PLANNING BOARD

- i. Major Site Plan; 1584 Forest Avenue; Acre Properties, Applicant. The Planning Board will hold a hybrid workshop to consider a major site plan application to facilitate the development of a 50-unit multi-family development with 50 off-street parking spaces on property located at 1584 Forest Avenue, to be accessed via Belfort Street. The subject property totals 66,650 square feet and is zoned RN-5 Residential and B-1 Neighborhood Business. A project and plan summary are available for viewing on the city's CSS Portal (<https://css.portlandmaine.gov/>) by referencing Plan Number PL-003161-2024.

To: Chair Brandon Mazer & Members of the Planning Board
From: Eric Freeman
Date: May 30, 2025
Re: 1584 Forest Avenue
Project ID: PL-003161-2024
CBL: 299 D027
Meeting Date: June 10, 2025

Figure 1: The revised pedestrian connection to Forest Avenue

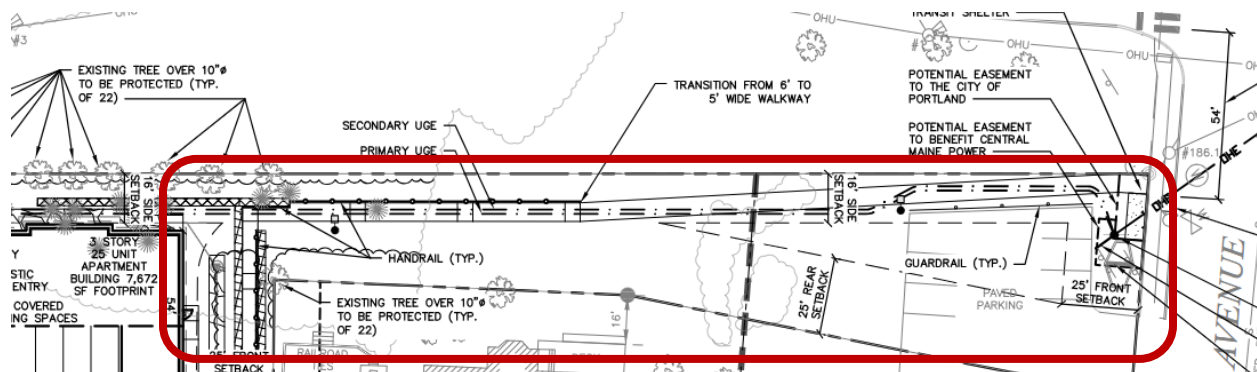
The Board noted that the proposed pedestrian connection to Forest Avenue did not fully extend to the public sidewalk and proposed transit shelter.

- **Conclusion:** The applicant has revised the design of the proposed walkway to connect directly with Forest Avenue. The applicant will also provide additional landscaping along the Forest Avenue frontage.

Figure 2: Proposed off-site mitigation on Belfort Street

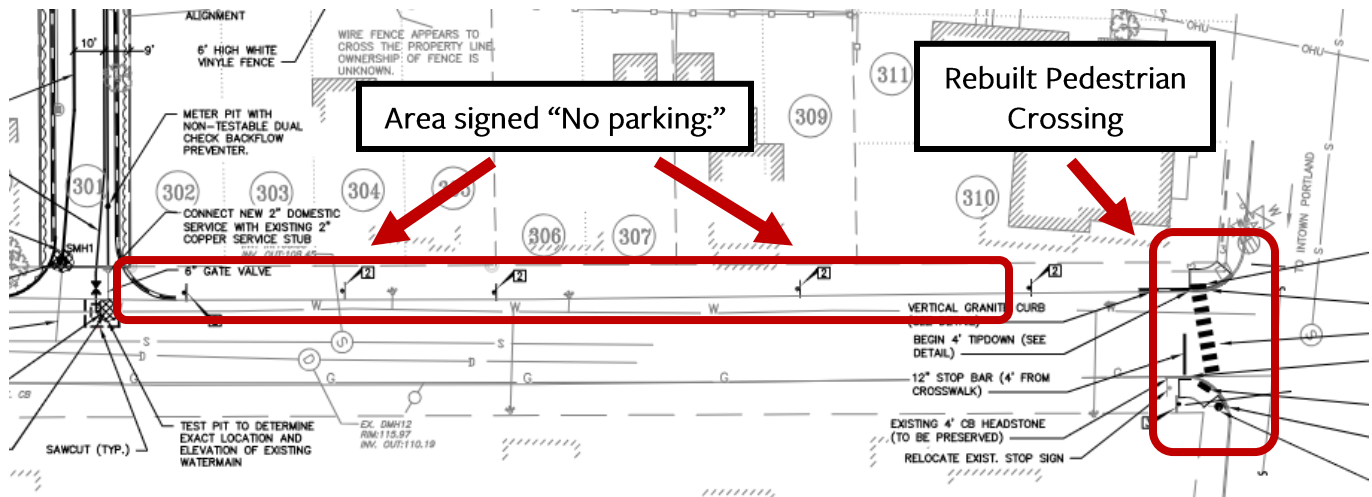
Based upon the traffic study provided by the applicant, Planning Staff and peer-review traffic engineers identified several off-site mitigation strategies to improve vehicular circulation and pedestrian safety in the vicinity of the proposed development. These mitigation strategies are intended to be proportional to the level of anticipated impact as outlined in Section 13.6.1.A.2

- Restricting on-street parking along the north side of Belfort Street extending approximately 320 feet from Moran's Market to the edge of the proposed driveway. This would reduce choke points within the right-of-way caused by parked vehicles and improve safety by creating new sightlines from four driveways. This change would impact approximately five on-street parking spaces.
- Reconstructing the pedestrian crosswalk at the intersection of Belfort Street and Forest Avenue with ADA-accessible ramps and detectable panels
